CONSTRUCTION PLANS FOR
KLAWOCK AIRPORT
PAVING
PROJECT NO. 69351
runway, taxiway,
apron & access road
paving & grading

1987
A.I.P. NO. 3-02-0154-03

A5-BUILT PLANS

STATE OF ALASKA
 DEPARTMENT OF TRANSPORTATION
 AND PUBLIC FACILITIES
 S.E. REGION, DESIGN & CONSTRUCTION
KLAWOCK AIRPORT PAVING
 PROJECT NO. 69351
 A.I.P. NO. 3-02-0154-03
PLAN AND PROFILE

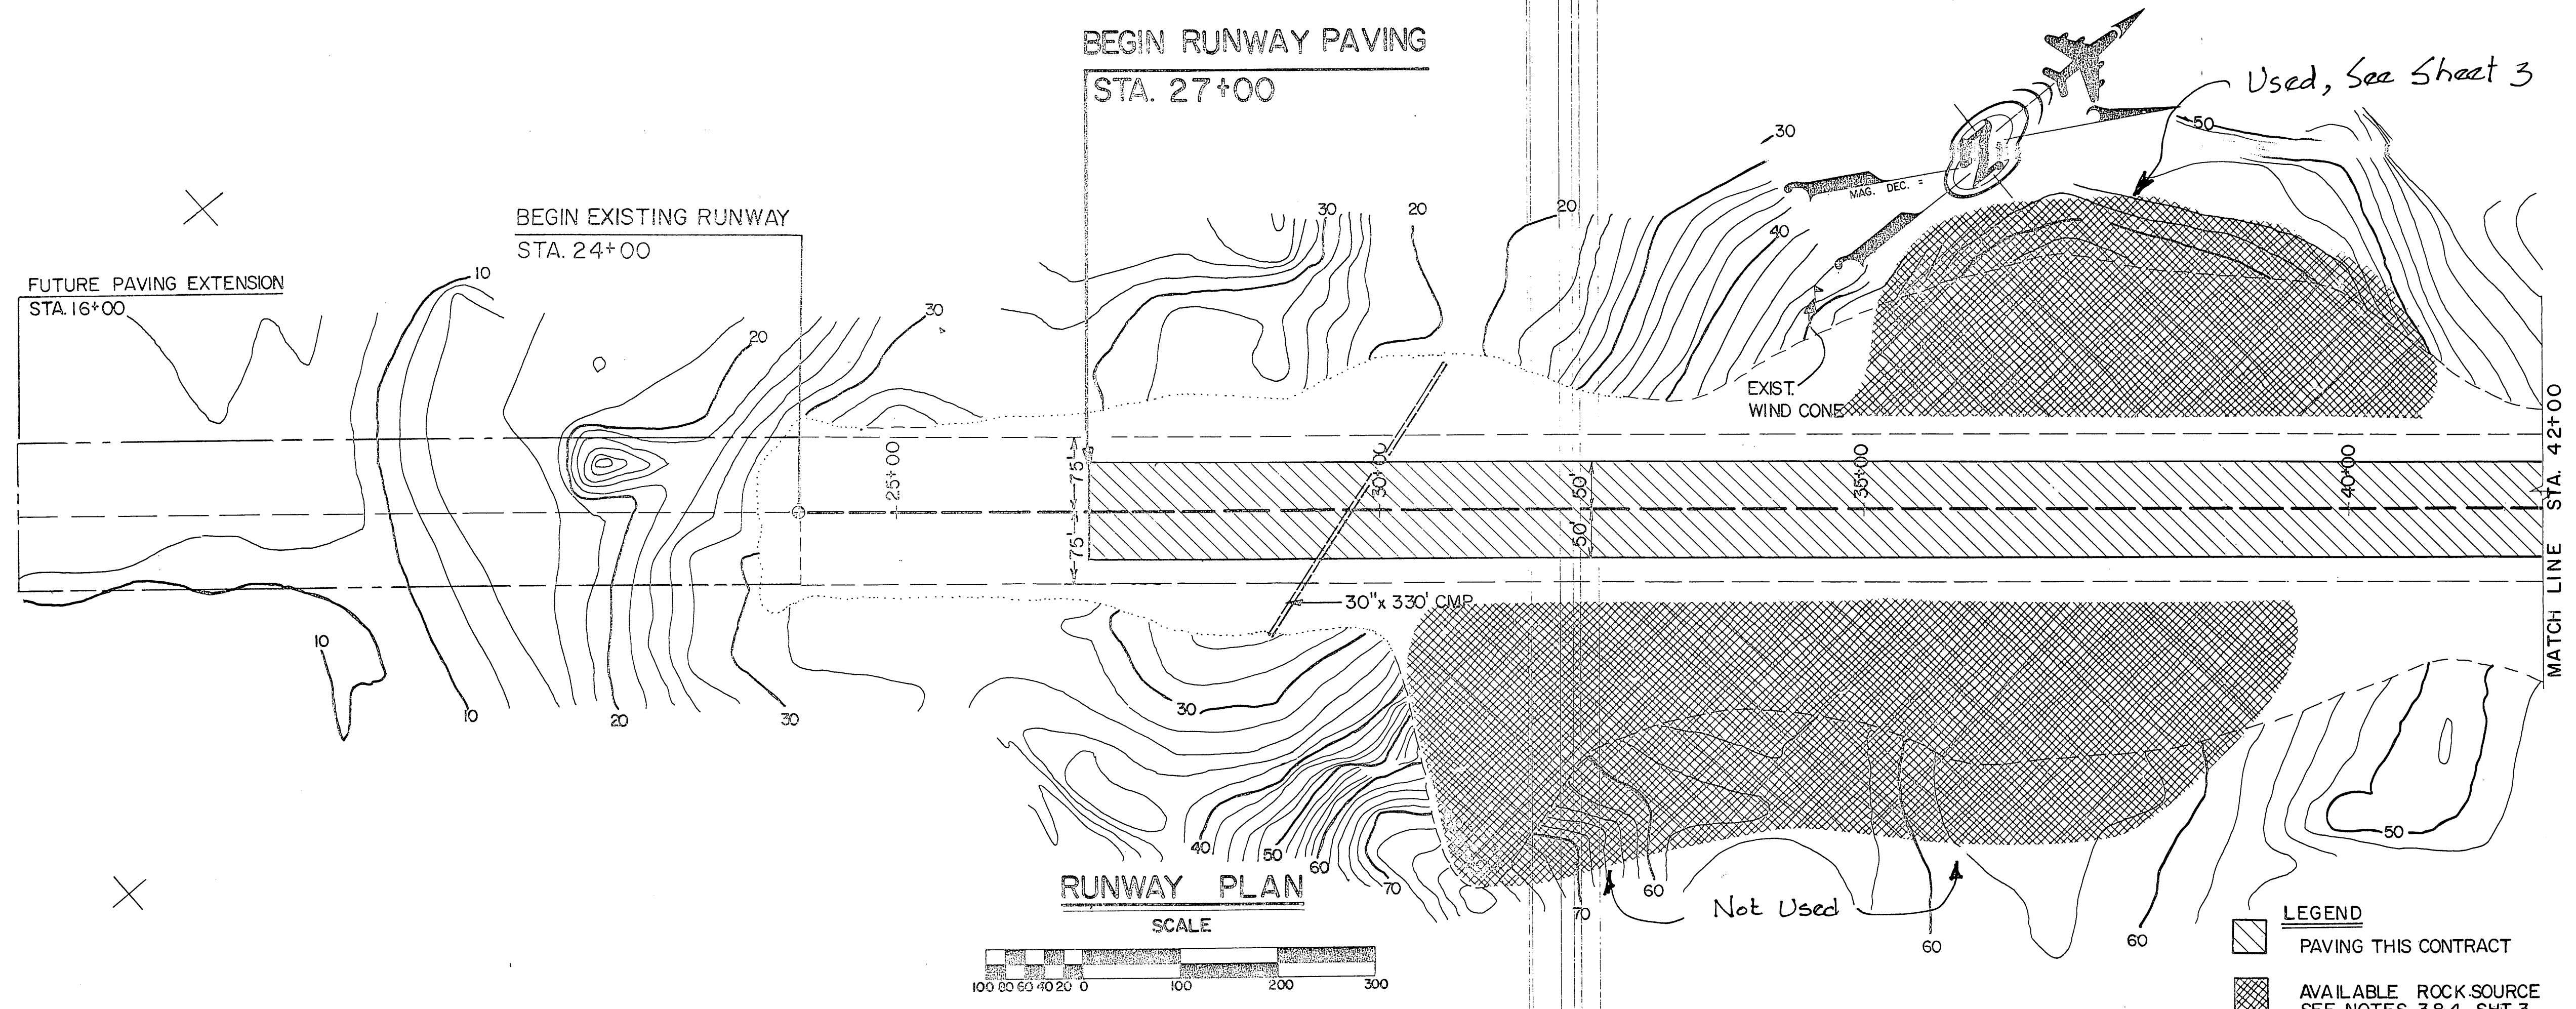
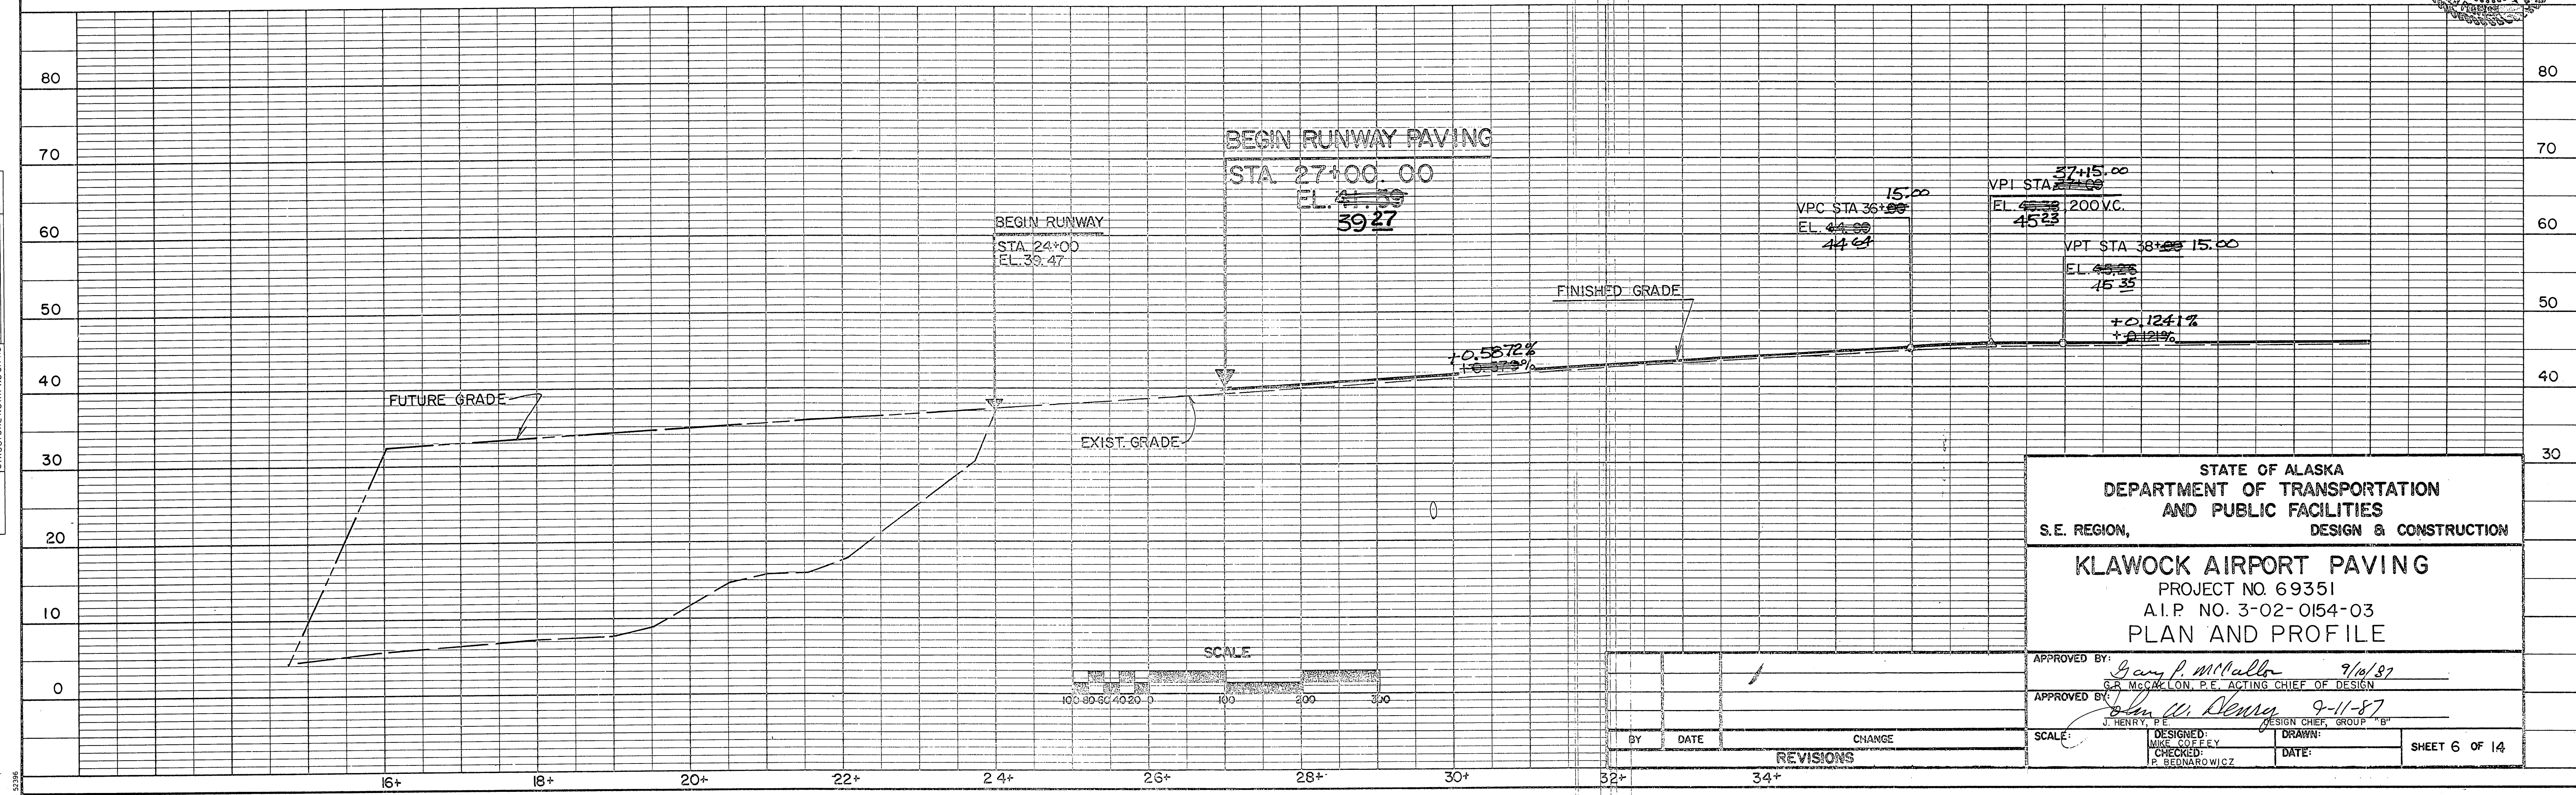
Used, See Sheet 3

APRON AND TAXIWAY REFLECTIVE MARKER RELOCATION DETAIL

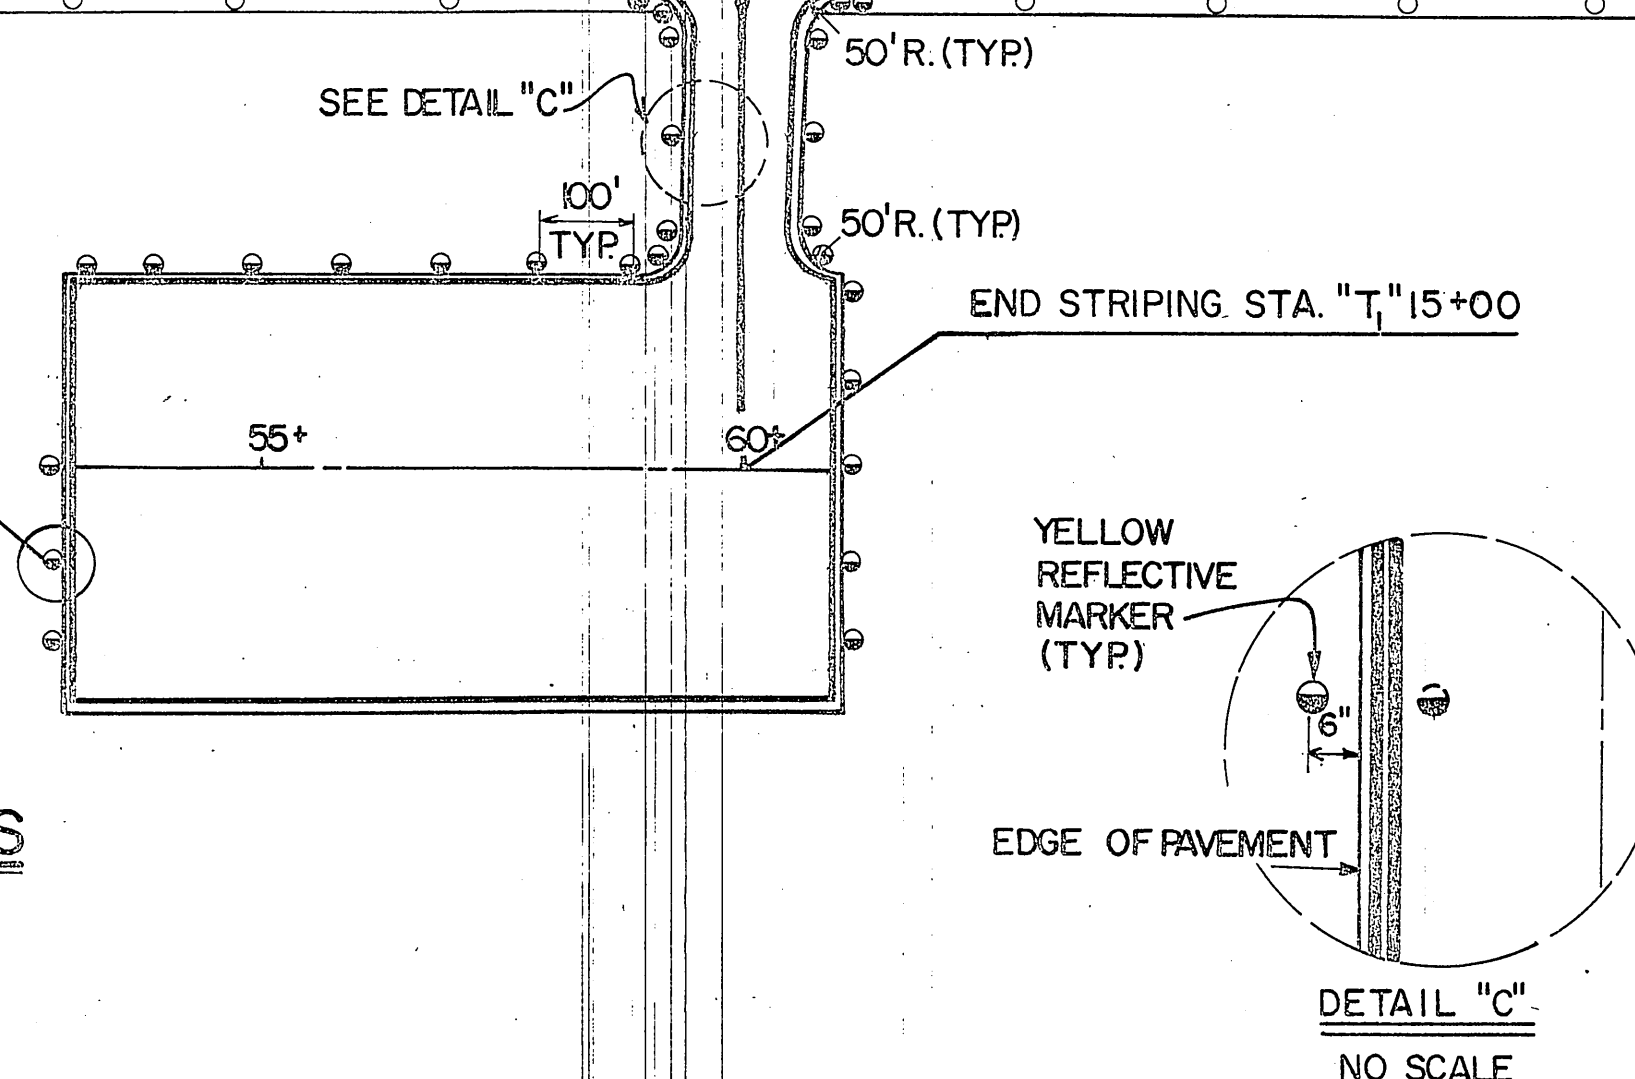
*REMOVAL OF THRESHOLD-MARKERS

~~CONTRACTOR SHALL NOT REMOVE THRESHOLD MARKERS UNTIL ALL STRIPING AND OTHER MARKING IS COMPLETED. THRESHOLD MARKERS SHALL BE REMOVED IN SUCH A MANNER THAT NO DAMAGE OCCURS TO THE REFLECTIVE MATERIAL OR TO THE UNITS. THRESHOLD MARKERS SHALL REMAIN THE PROPERTY OF THE STATE, AND THE CONTRACTOR SHALL PLACE THRESHOLD MARKERS AT A LOCATION DESIGNATED BY THE PROJECT ENGINEER. ALL WORK PERTAINING TO REMOVING THRESHOLD MARKERS IS INCIDENTAL TO OTHER ITEMS OF WORK.~~
